From:	Vicki Golin
Sent:	5/07/2024 3:23:23 PM
То:	Council Northernbeaches Mailbox
Subject:	TRIMMED: DA2024/0745. 33 Quinton Road Manly
Attachments:	DA2024_0745_33QuintonRd.pdf;

### Re:Development Application No. 2024/0745 Property:33 Quinton Road MANLY

I am the owner of No. 31 Quinton Road, Manly, the semi-detached dwelling which is attached to No. 33 on the southern side. I first moved to No. 31 when my husband bought it in 1983 and have owned it since 2004. The proposal includes building up on the common party wall, extending the common party wall 1.9m to the rear, as well as a southern roof that slopes straight down onto the roof of No. 31.

Survey Plan 31 Quinton Road

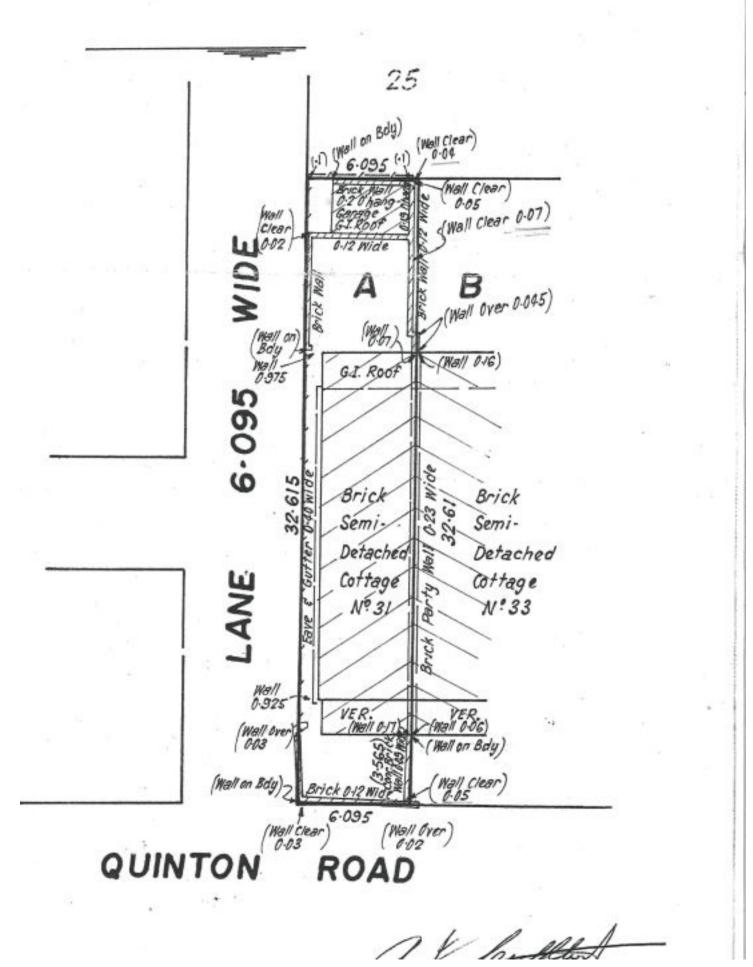
- 12. That nothing be built on No. 31, including my half of the party wall, without my written agreement.
- 13. Note: From the survey plan of No. 31 the front and rear boundary brick boundary fences between No. 31 and No. 33 are entirely in No. 31, except for the first metre at the back of the house (Survey Plan Attached). Both walls have cracks in them, the latter from top to bottom, where the bend in the wall is. At some stage, I will probably need to remove both of them. I ask that the owner of No. 33 not attach anything to them or build onto them.
